ECN/PCN No.: M1364

Product Description: Low Profile Shielded SMD Chip Power Inductor	Abrakon Part Number / Part Series: ASPI-0615FS Series	☐ Documentation only ☒ Series ☒ ECN ☐ Part Number(s) ☐ EOL
Affected Revision: E	New Revision: F	Application: ☐ Safety ☒ Non-Safety

6.0 Mechanical and Materials

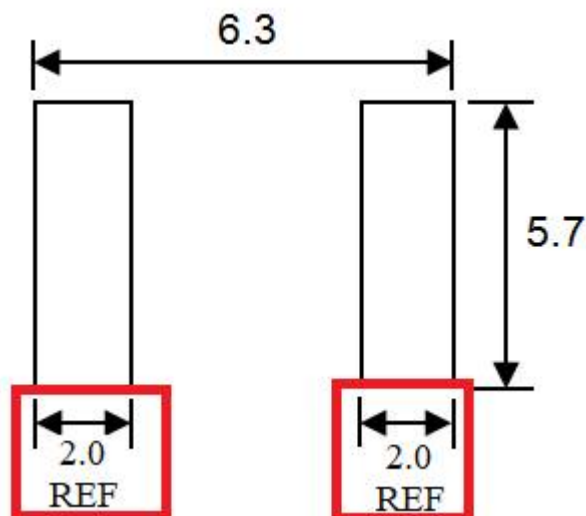
A	B	C	D Typ.
6.0±0.3	6.0±0.3	2.0 MAX	1.50

8.0 Packing

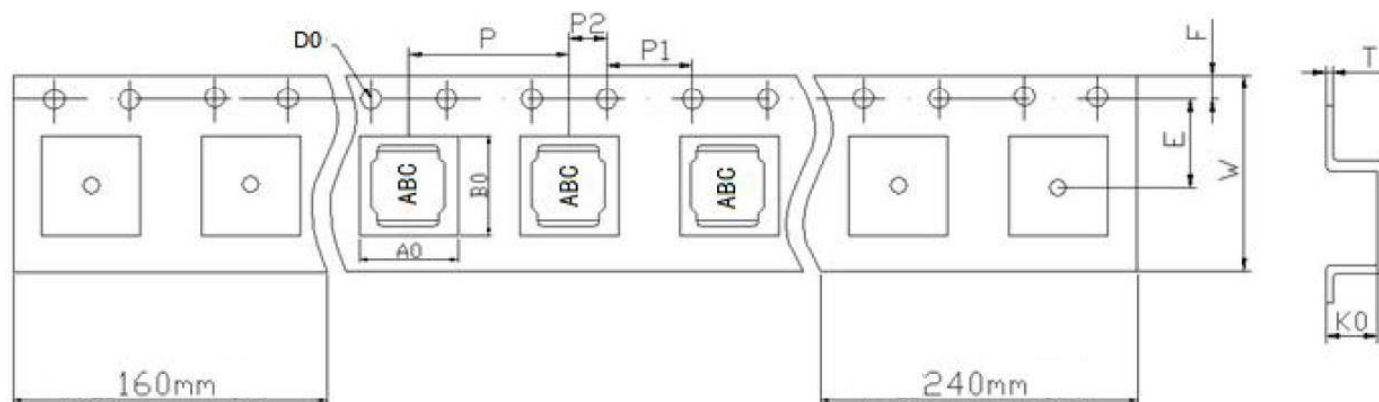
T2: 3,000pcs / reel

Dim	W	A0	B0	K0	P	E	F	D0	P0	P2	T
ASPI-0615FS	12.0±0.3	6.3±0.1	6.3±0.1	2.2±0.1	8.0±0.1	7.5±0.1	1.75±0.1	1.5±0.1	4.0±0.1	2.0±0.1	0.35±0.05

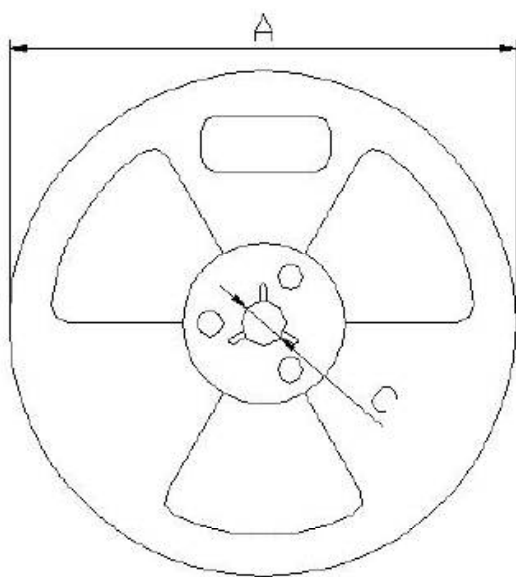
A	330±0.5
B	100±0.5
C	13.5±0.5
W	12.5±0.5
